**Project: IEEE P802.15 Working Group for Wireless Personal Area Networks
(WPANs)**

Submission Title: comment resolution assignment

Abstract: proposes comment resolutions for a set of CIDs

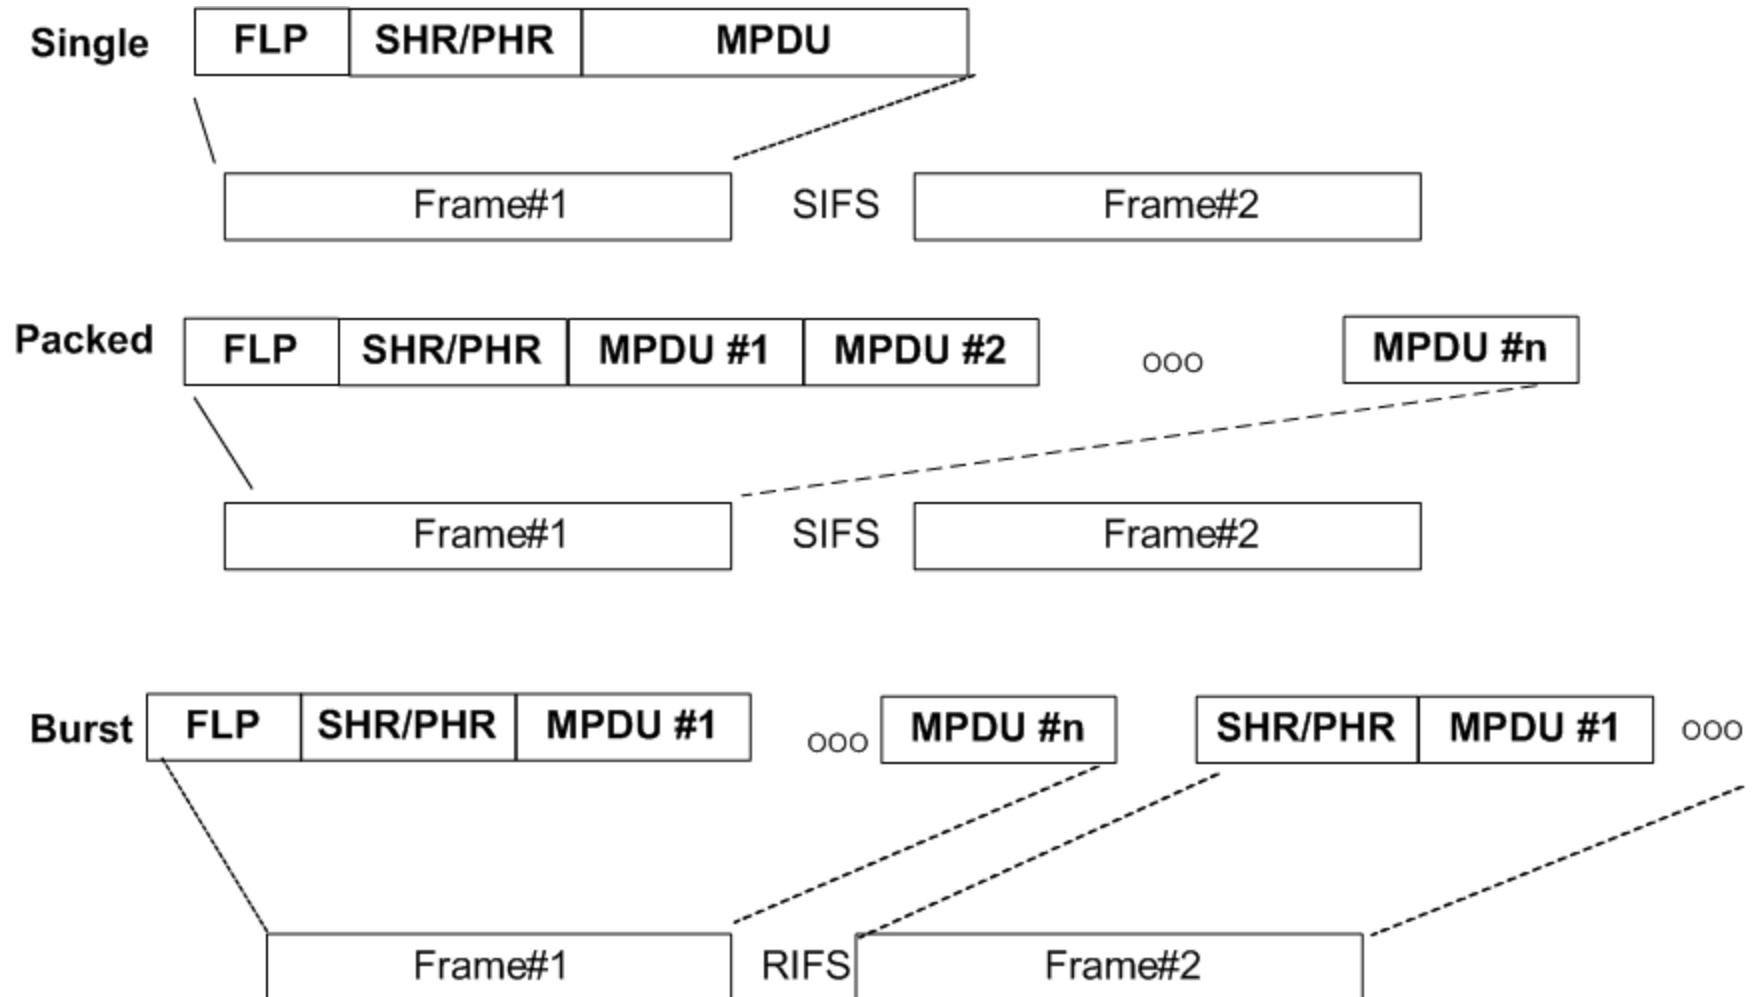
- In Figure 20, in Burst mode, there are two MAC PDU #n. These should be fixed.
- Figure 20 - Burst Mode - shows the same MAC PDU being transmitted twice, in both Frame #1 and #2. This figure does not align with the text
- (SY) In Burst mode, both packets are shown with the label "MAC PDU #n". I believe that the labels should be different

- Redraw the figure with correct PDU numbers.
- replace first MAC PDU #n with MAC PDU #1 and second MAC PDU #n with MAC PDU #2

- Comment accepted in principle. However, fix is not easy.

Instruction to editor: Update Figure 20

Define FLP – Fast Locking Pattern

Page 38, line 33. Add “The FLP shall be dropped in the burst mode.”

Update figures 13-17 to show FLP before preamble. Redefine preamble to exclude FLP.

Work with Sridhar to obtain visio files for Figures 13,14,15,16,17,20.
